CONVAIR

COMMERCIAL CHANGE PROPOSAL

SPEC NO.: ZD-22-003

MODEL: (880) 22-2

Enclosure to CCP No. 154A

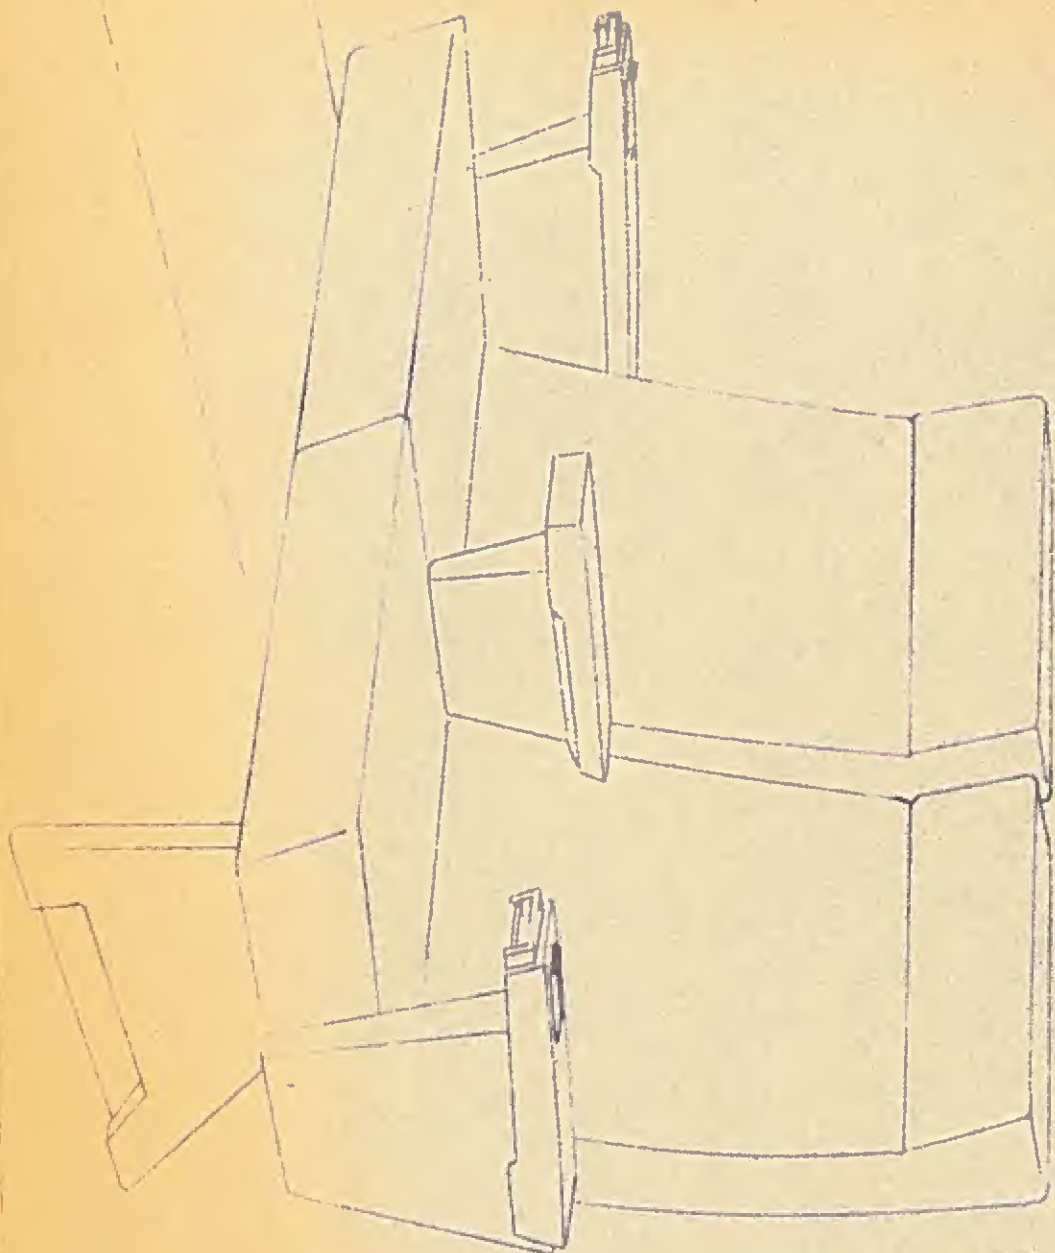
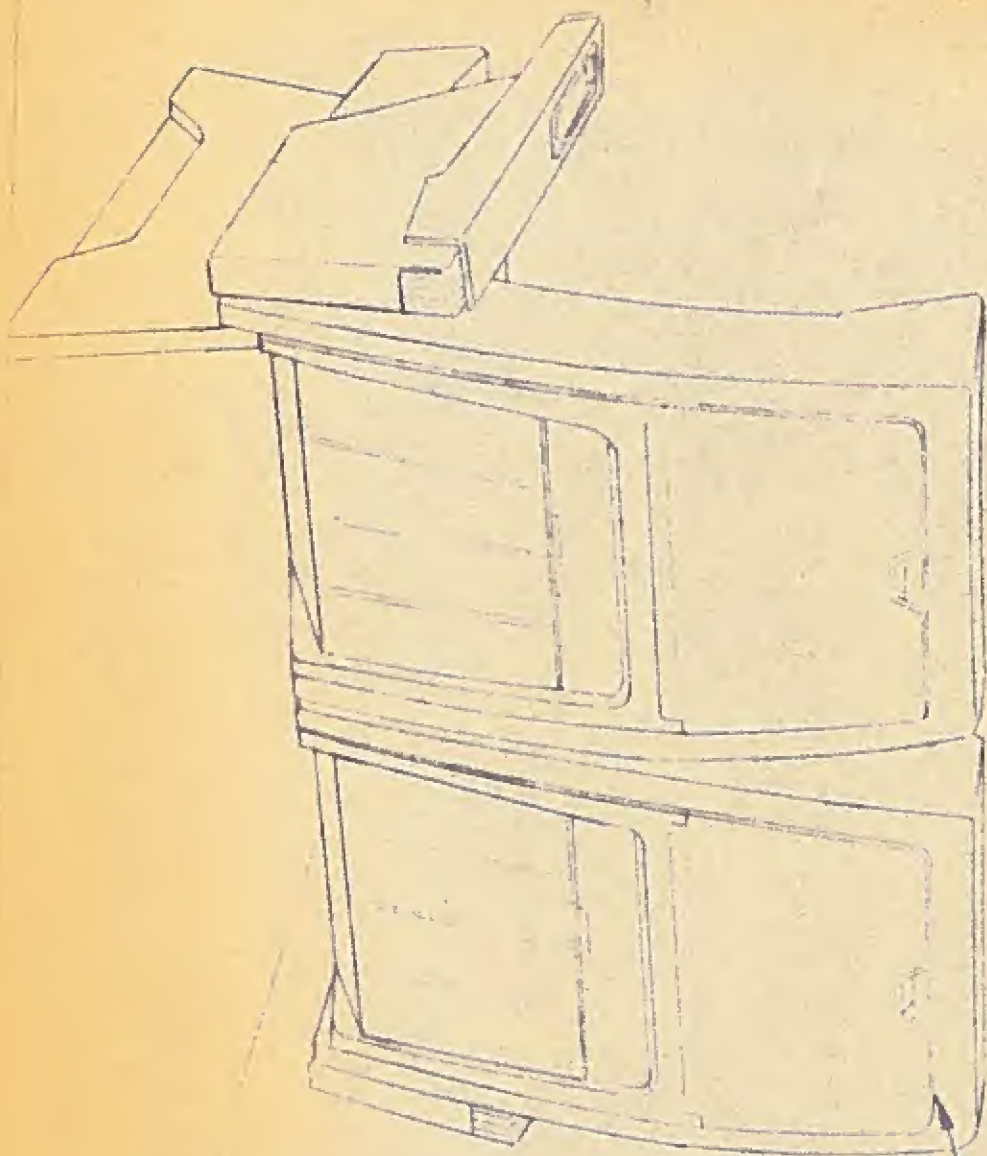
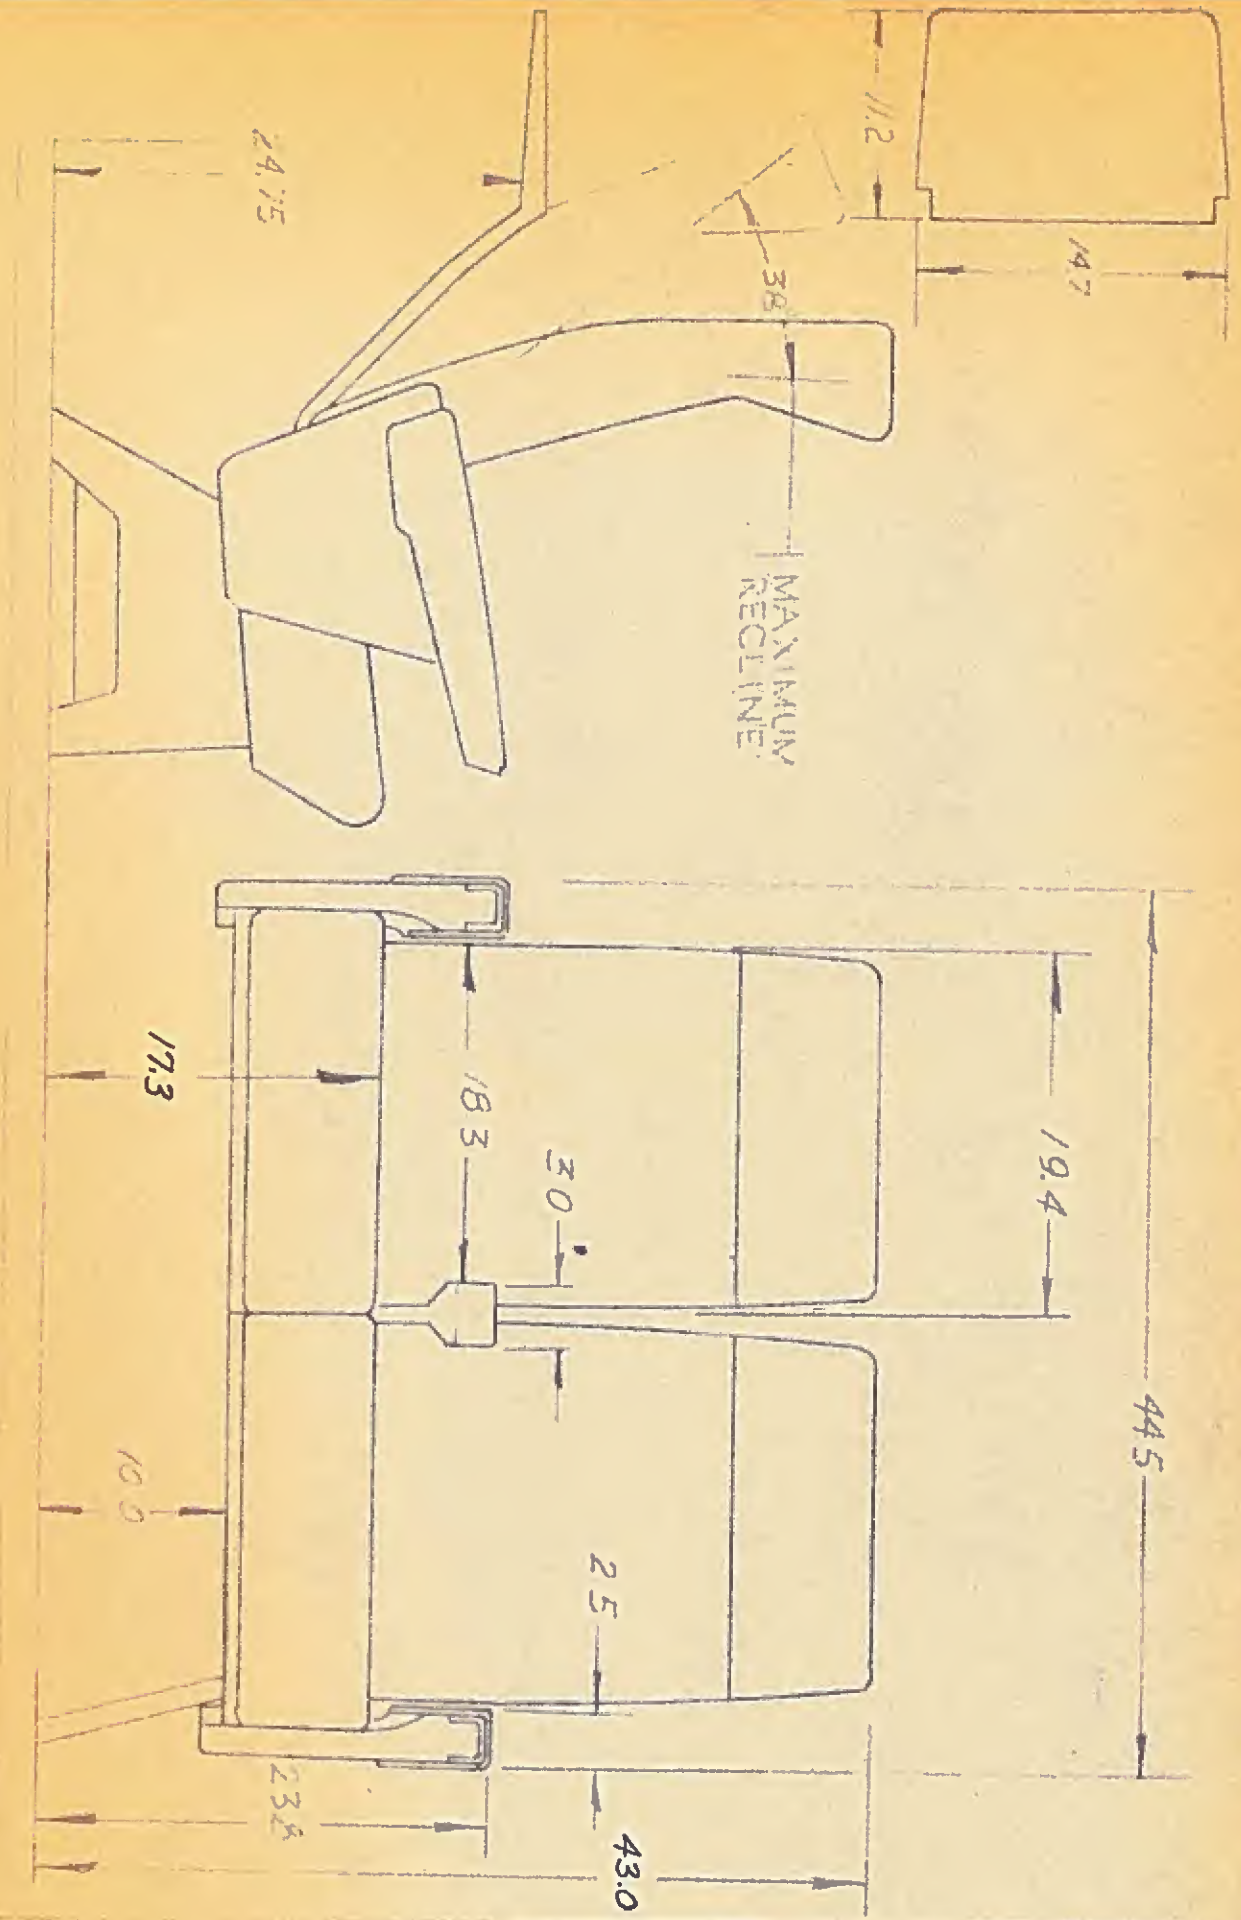
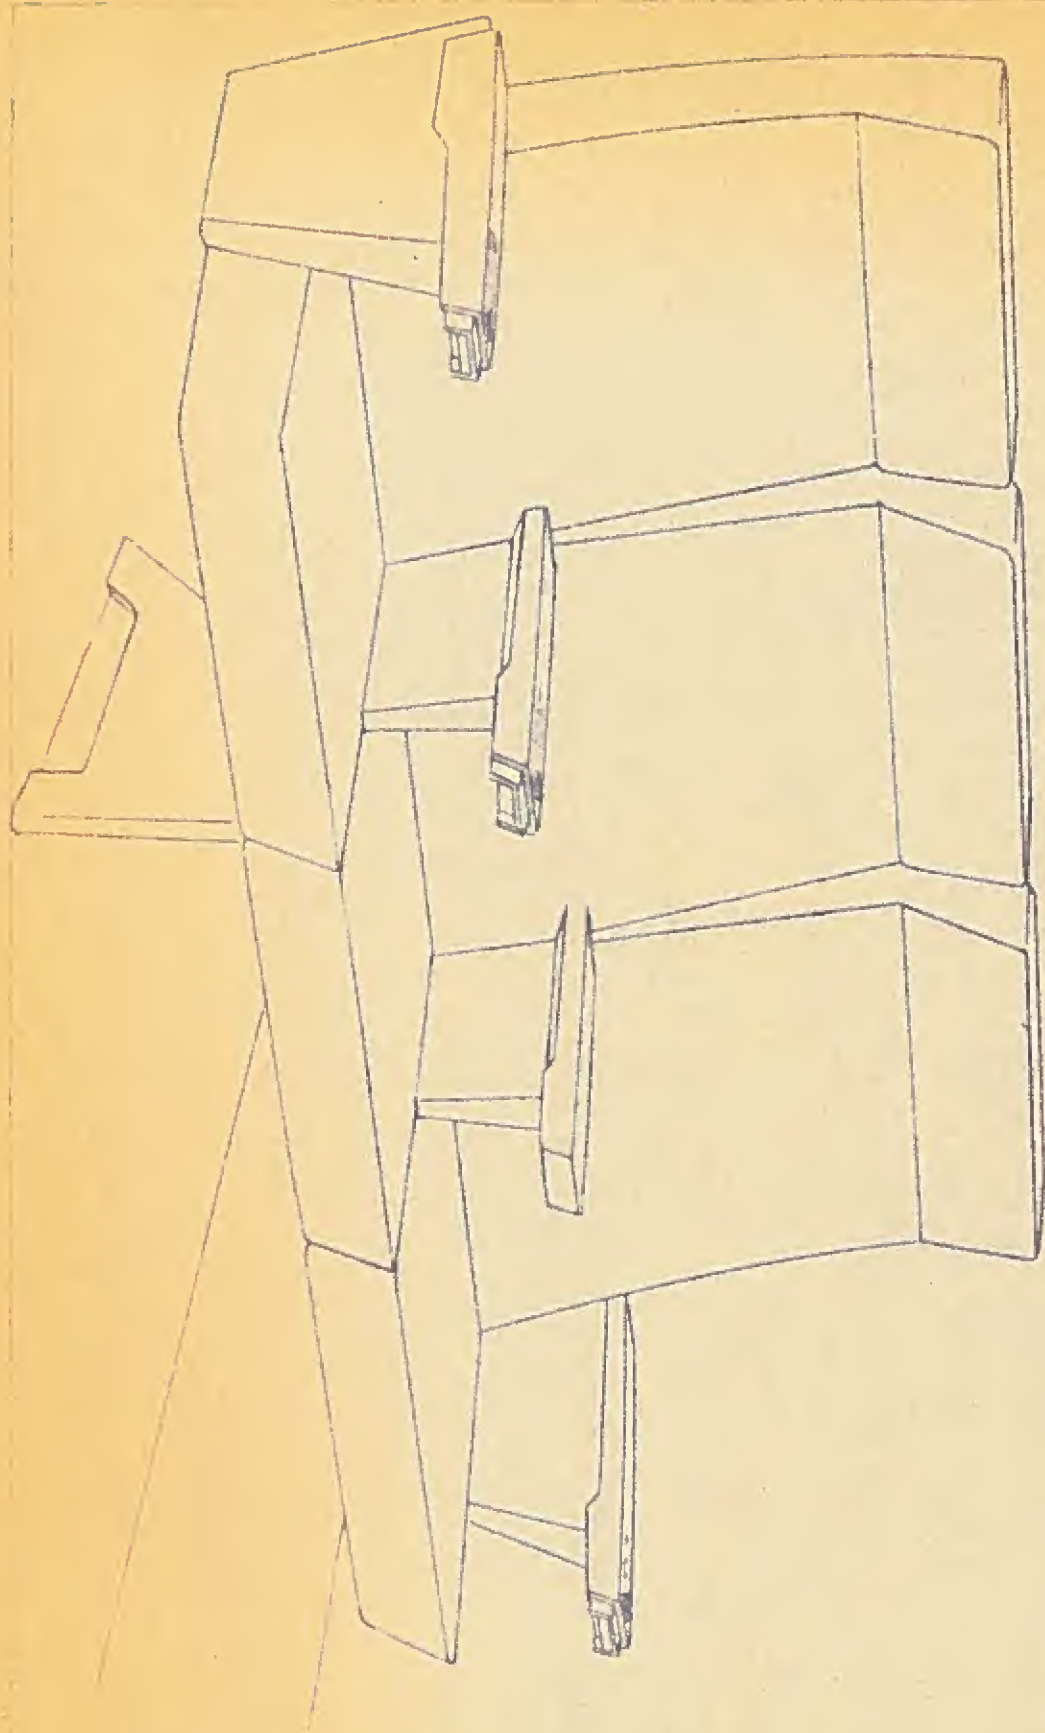
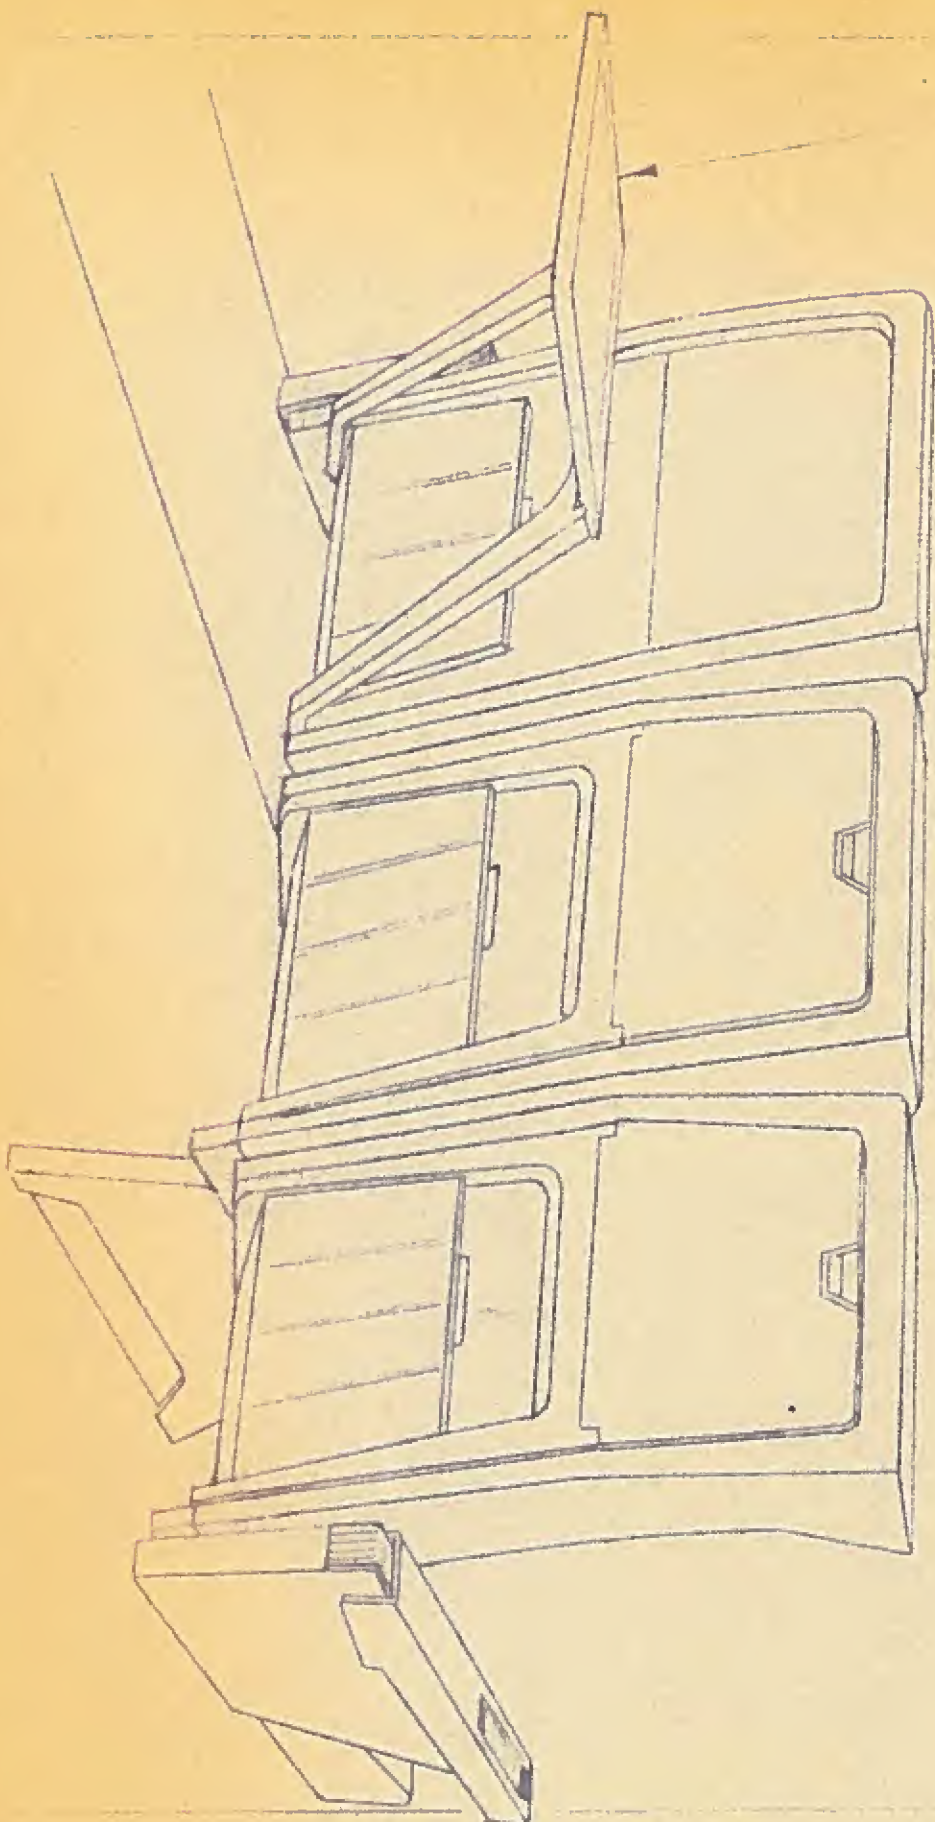
Item "A" in paragraph 3.19.1.1.6.2 of this proposal, will provide five plug-in trays for first six rows of Customer order per airplane. Five additional plug-in trays will be provided for 18 or more coach seat rows per airplane. Receptacles for plug-in trays shall be provided as loose equipment on all coach seats not having receptacles installed.

The following parameters shall be used in the coach seat design:
